**ZONING CASE NUMBER:** C14-2016-0039 – Thornton II

### **ZONING CHANGE REVIEW SHEET**

**CASE:** C14-2016-0039 – Thornton II **P.C. DATE:** June 14, 2016

Neighborhood Traffic Analysis for Thornton Road

Figure 2 – Thornton Road parcel map

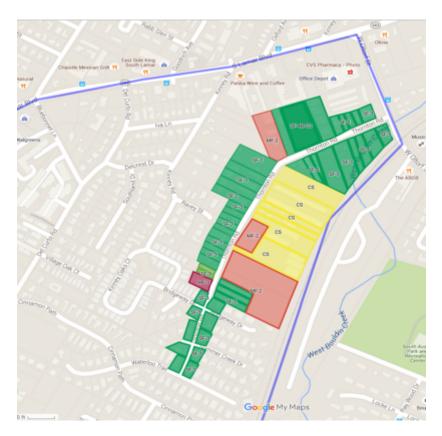
The characteristics above are graphically presented in Figure 2 The current 6 CS properties are located 1000 feet into the core of the neighborhood and surrounded by residential properties. Historically these properties were listed as Residential A per Austin City Code or the equivalent of SF-3. Section 2 provides a brief history of Thornton Road zoning cases.

Figure 19 Drainage of Del Curto Watershed to Subject Property

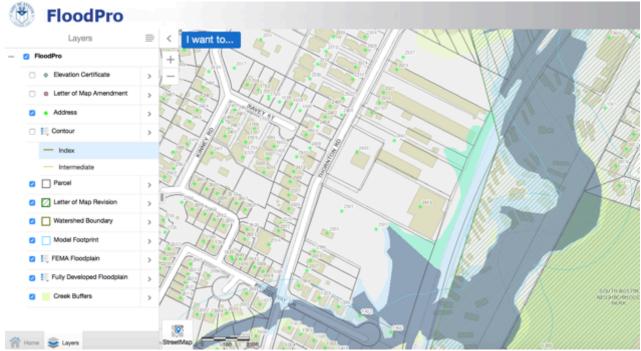
The Thornton Road area faces significant impacts from flooding ass described in the South Lamar Mitigation Plan and the plan for the Del Curto Storm Drain Improvements –Phase 1B plan. The overall development of the area always presents concerns on flooding especially when existing infrastructure problems are not addressed. Any proposed development on Thornton needs to be carefully evaluated for the full impact on the West Bouldin Creek watershed. The cumulative development on the southern part of Thornton presents potential issues for Bridgeway if not done properly as shown by the Austin FloodPromap.
